ADDENDUM NO. 2:
 The following changes and additions shall be made to the Plans and proposal. When this addendum conflicts with the specifications, plans, or special provisions or Addendum No. 1, THIS ADDENDUM SHALL GOVERN.

RECORD DRAWING

CITY OF WICHITA

TRAFFIC SIGNAL PLAN
KELLOGG & TYLER ROAD

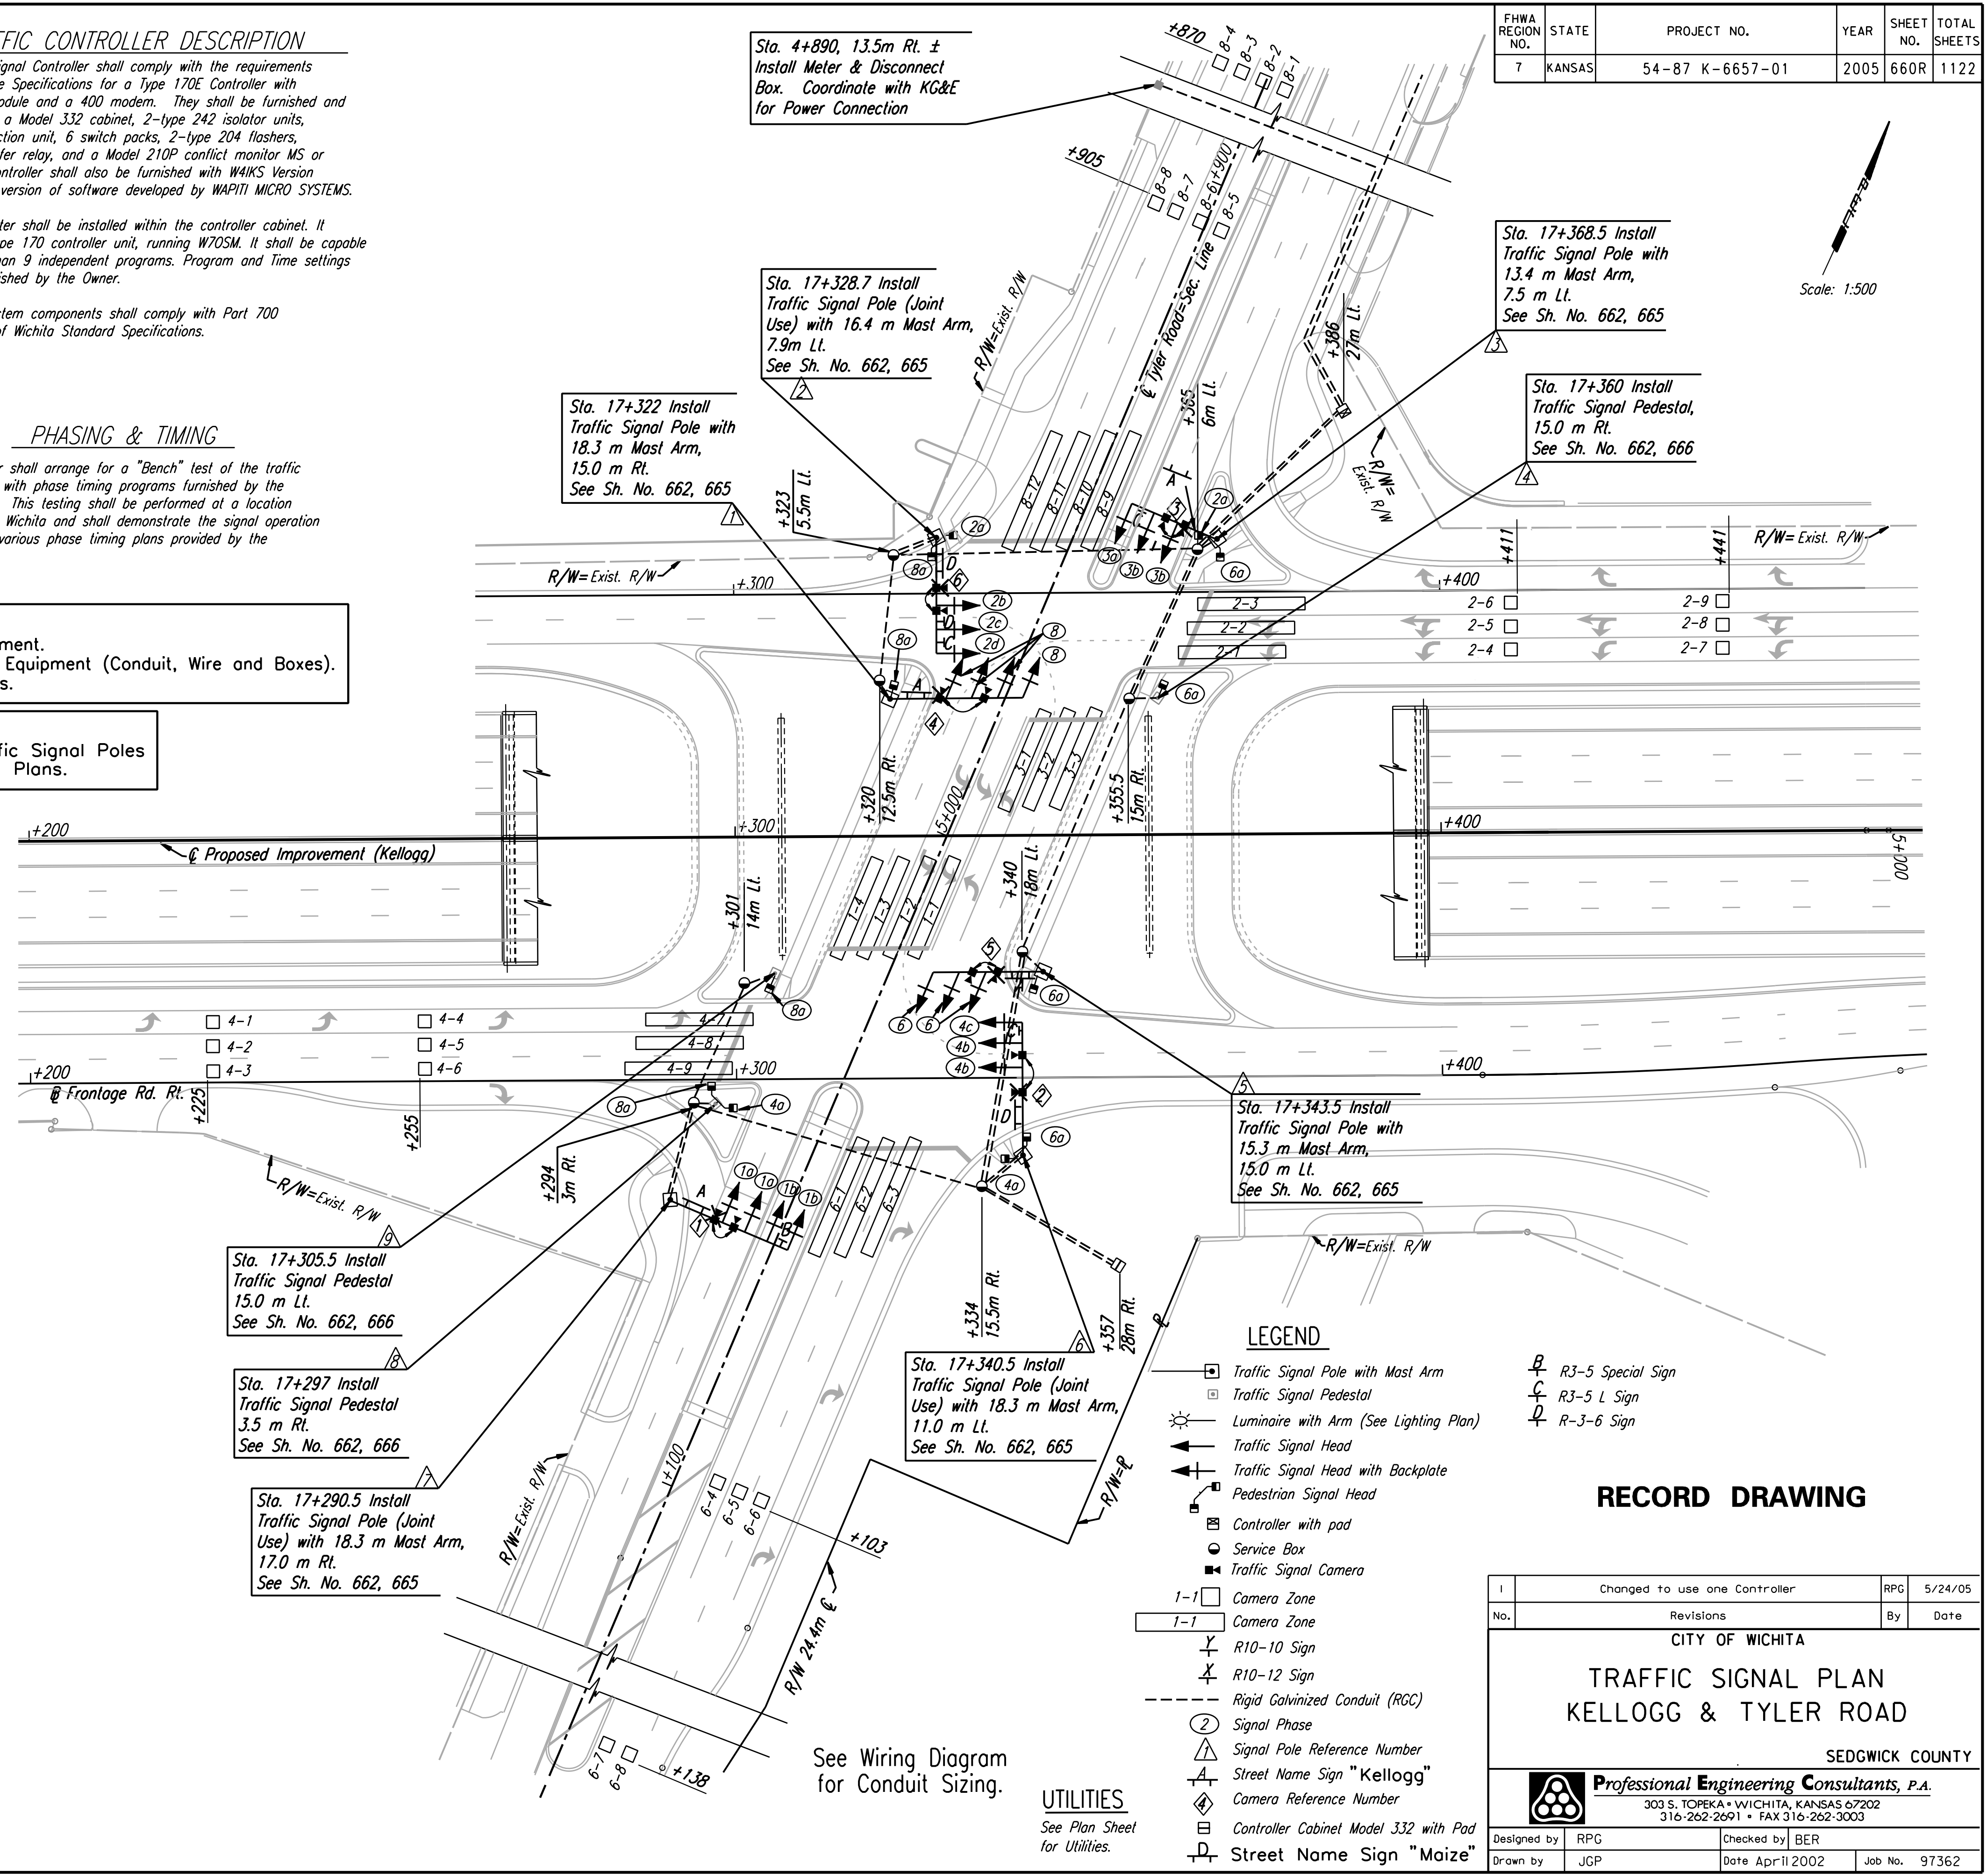
Sheet 660
 1. Add Note-Conduits for joint use light poles shall be included as part of the Traffic Signal Installation. Refer to the wiring diagram on Sheet No. 661 for number and size of conduits.
